# 9.7 109-113 Liverpool Street, Hobart - Partial Demolition, Alterations and Signage

PLN-19-909 - File Ref: F20/31791

Application No: PLN-19-909

Proposal: Partial Demolition, Alterations and Signage

**Figure 3**: Proposed Liverpool Street elevation and streetview illustrating alterations and signage.

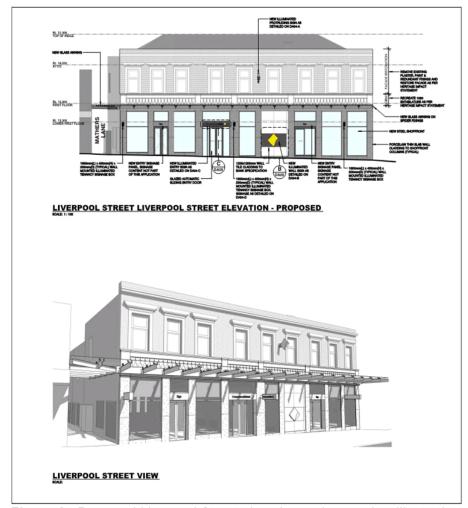
The removal of the awning and flagpoles will result in the substantial diminution of the significance of the place through the loss of significant streetscape elements and the new glazed awning is incompatible in its design, materials, siting and height (ie not in alignment with the existing awnings on adjoining properties. The new works to the facade to 'restore' the facade are unnecessary and inconsistent with the local historic values of the place, its evolution as a department store having gone through major phases of change. The proposal does not satisfy E13.7.2 P1.

The new awning does not complement the place as it is too high, of the wrong materials and will be highly contrasted in form and detail to the existing plain facade. Subservient means "serving or acting in a subordinate capacity", while the word complementary means: "something that completes or makes perfect, in harmony with" or "making up a harmonious whole", see *S Solvyns v Hobart City Council & Ors* [2017] TASRMPAT 8. The proposed awing does not achieve this, is discordant and visually intrusive and introduces incompatible design to the place. Being on the front elevation of the building, there is a requirement that the design complements the original structure. The existing awning does this.The new awning does not. The proposal does not satisfy E13.7.2 P2.

The glazed form does not respond in the sense of it holding a balanced answer or response. The highly dominant metal fins and sheet glazing does not reflect the heritage values of the now plain Victorian Georgian facade. It is improtant to note that the clause clearly states that materials, built form and fenestration **must** respond, but any new fabric **should** be readily identifiable. Clearly the word **must** is a clear directive while the word **should** is advice. The new awning does not satisfy E13.7.2 P3.

Figure 4: Roof plan illustrating proposed demolition

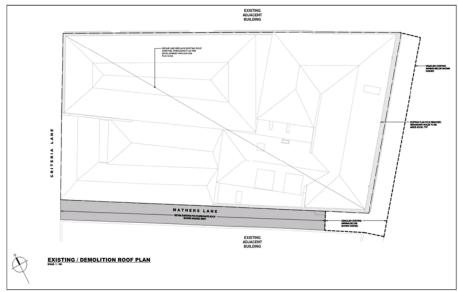
- 1. The proposal does not meet the acceptable solution or the performance criterion with respect to clause E13.7.1 A1 or P1 of the *Hobart Interim Planning Scheme 2015* because proposed demolition would result in the loss of fabric of significance that contributes to the historic heritage significance of the place, and it has not been demonstrated that:
